Docket No. STN 52-001

Subject: Submittal Supporting Accelerated ABWR Review Schedule - DFSER
Confirmatory Items 7.2.5-1 and 7.2.5-2

7.2 REACTOR PROTECTION (TRIP) SYSTEM - (RPS) INSTRUMENTATION AND CONTROLS

Figure 7.2-1 ABWR SSLC CONTROL POWER SCHEME (SEE ALSO FIGURE 8.3-1)

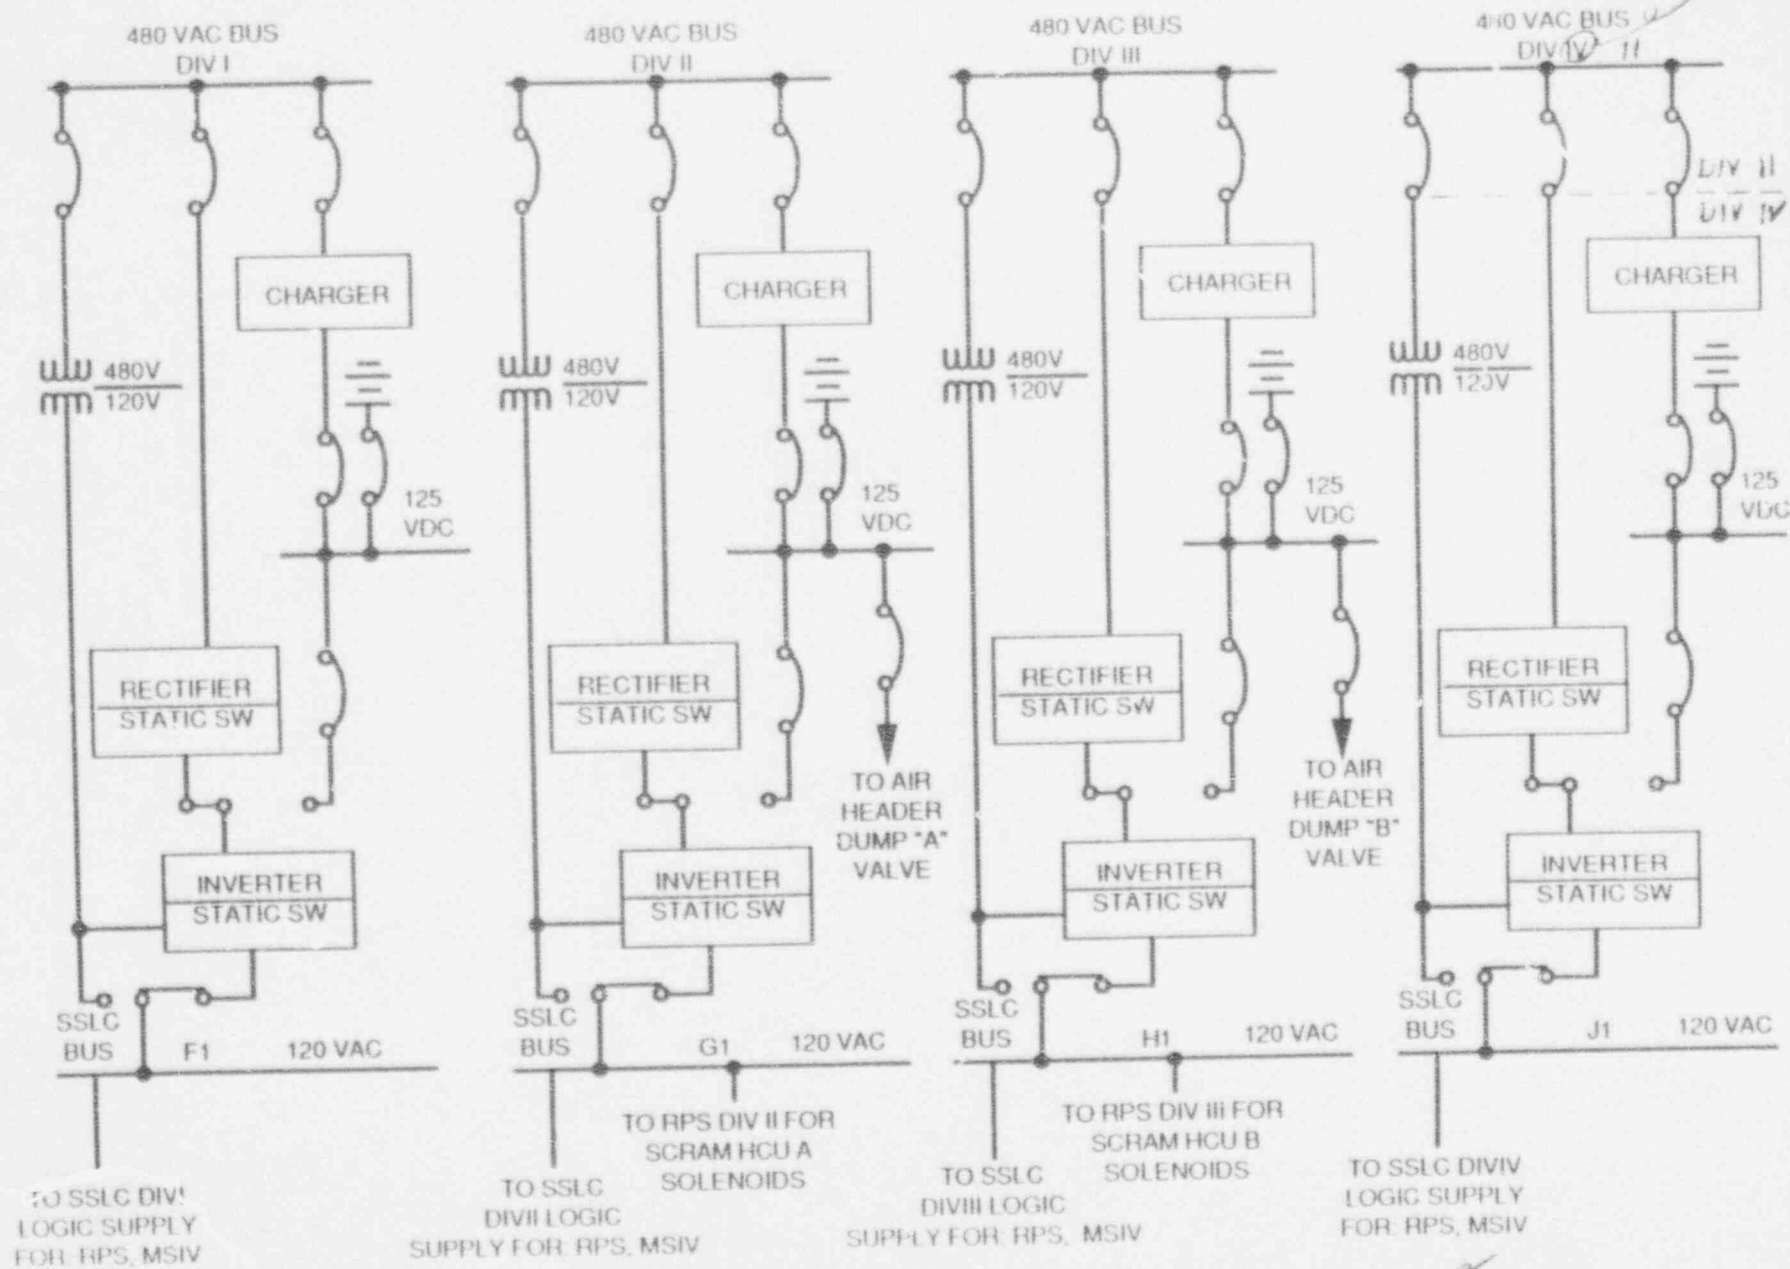
DFSEER ITEM NUMBER	DFSEER BULLET STATEMENT	SSAR REFERENCE	GE RESPONSE
7.2.5-1 CONF	SSAR Chapter 8 and the corresponding SER section discuss the plant station power. For the SSLC, the power is supplied by four independent and separate Class 1E, 120 Vac sources, which are each backed up with a Class 1E, 125 Vdc battery source through an inverter. Divisions 1 and 4 are supplied from the same 480 Vac source, as indicated by SSAR Figure 8.3-6. GE must revise SSAR Figure 7.2-1 to reflect the power supply design, since that figure incorrectly shows a fourth division of 480 Vac power. GE has committed to revising Chapter 7 of the SSAR to reflect the electrical distribution as described in Chapter 8 of the SSAR. This is confirmatory Item 7.2.5-1.	Figure 7.2-1	Figure 7.2-1 has been modified as marked in the attached. Note that the division which feeds Division IV is now Division II, rather than Division I. This change was made because the HVAC which supplies the Division IV battery room is Division II.

CNFM
7.2.5-1

Figure 8.3-

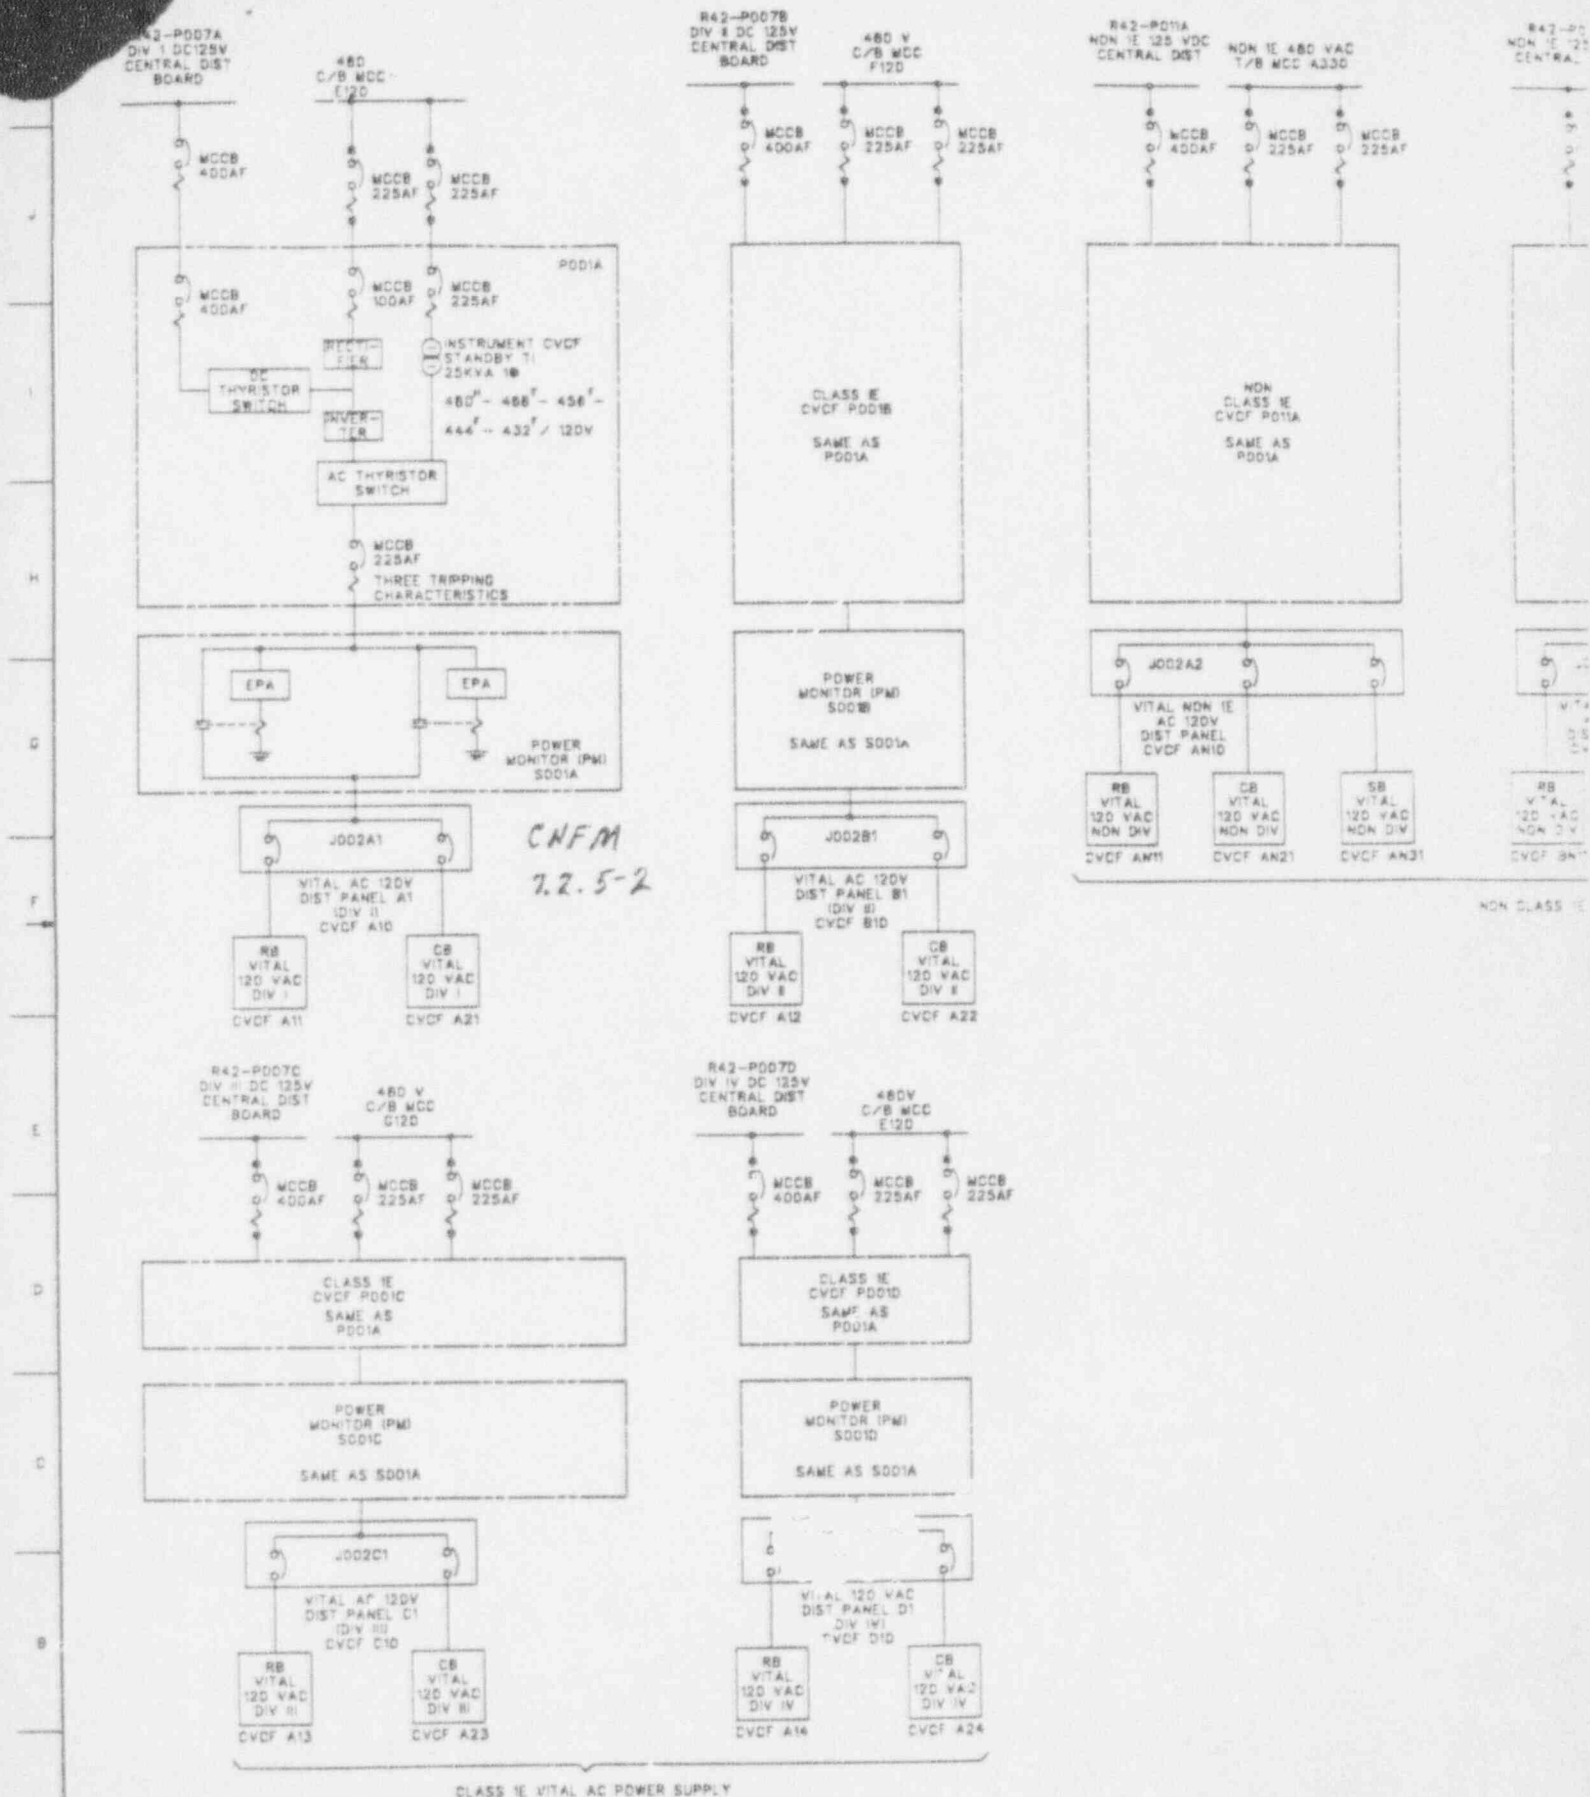
7.2.5-2 CONF	The ITAAC and DAC for the EPAs must include a verification that the wiring to the solenoid valves is sized so that normal voltage drop in the cables will not result in insufficient voltage being supplied to the solenoid coils. the ITAAC and DAC also must include a verification that the neutral leads of the scram pilot solenoid valve coil windings are configured so that credible faults (such as hot shorts) will not prevent the valves from performing their safety function. GE has verbally committed to include the EPAs in the ABWR design. These issues are Confirmatory Item 7.2.5-2.	FIGURE 8.3-3, SH. 1	The EPAs are included in the design, as shown on Figure 8.3-3, Amendment 23.
